Town of Franklin

Conservation Commission

Re: 1199 West Central Street – Garelick Farms
MassDEP File No. 159-1322
Notice of Intent Peer Review #2

BETA Group, Inc. (BETA) has reviewed revised documents and plans for the project entitled ***Garelick Farms Flood Resiliency Improvements*** (the Project), located at ***1199 West Central Street*** (the Site) in Franklin, Massachusetts. This letter is provided to present BETA's findings, comments and recommendations.

G-003

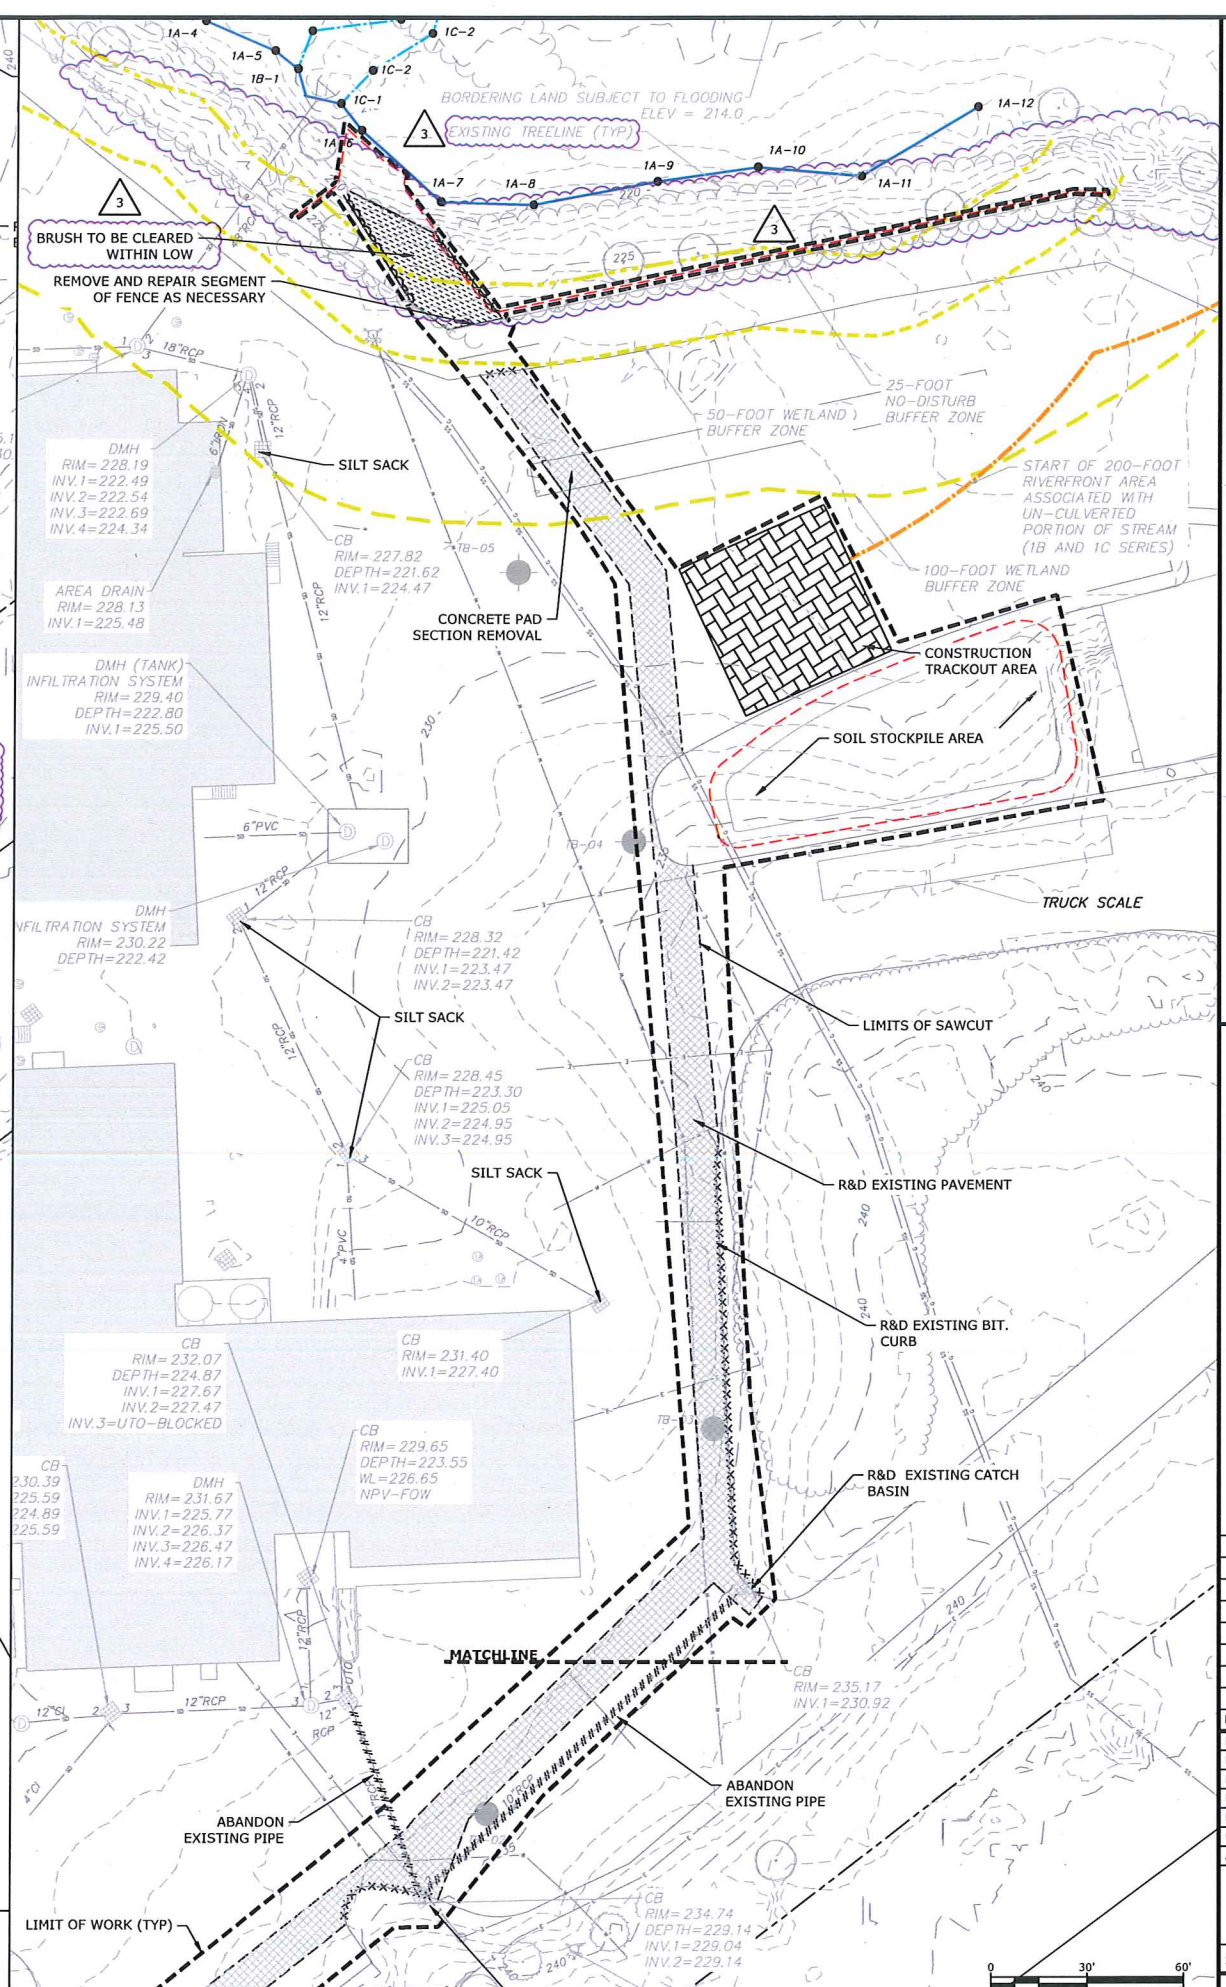
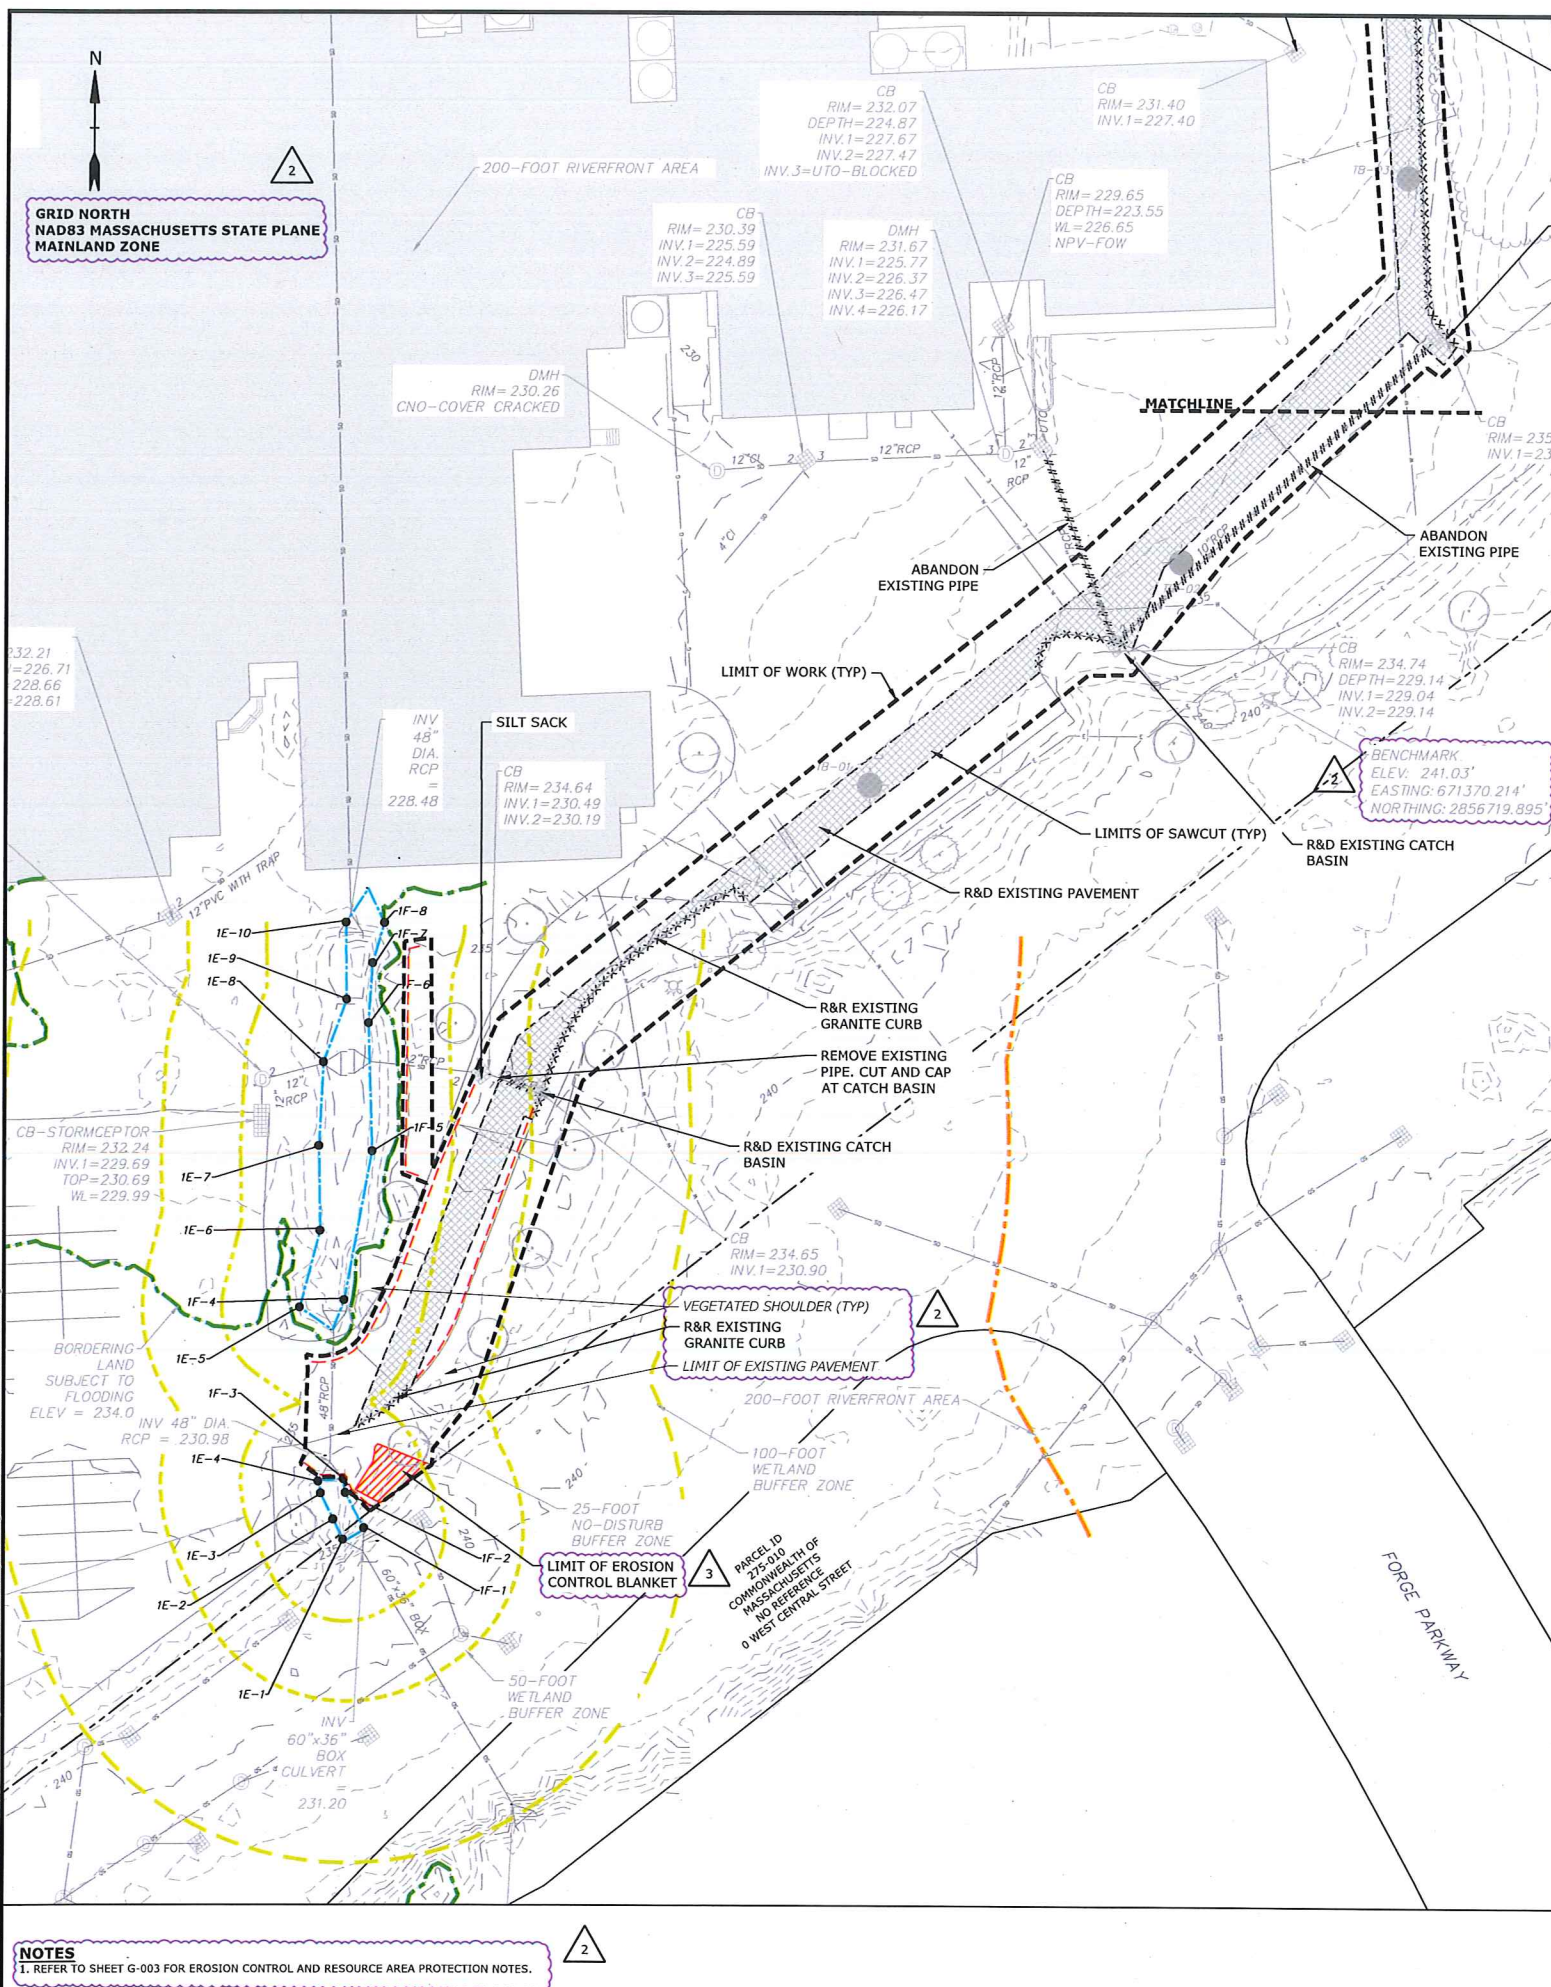
- c. A Construction Sequence with all proposed activities within Jurisdictional Areas should be provided on the plans per Bylaw Regulations Section 7.18.1.14.

- W16. The Applicant should provide the Construction Sequence on the plans per Bylaw Section 7.15.

TB: This information has been added to the plan set on sheet G-003.

TB: This information has been added to the plan set on sheet G-003.
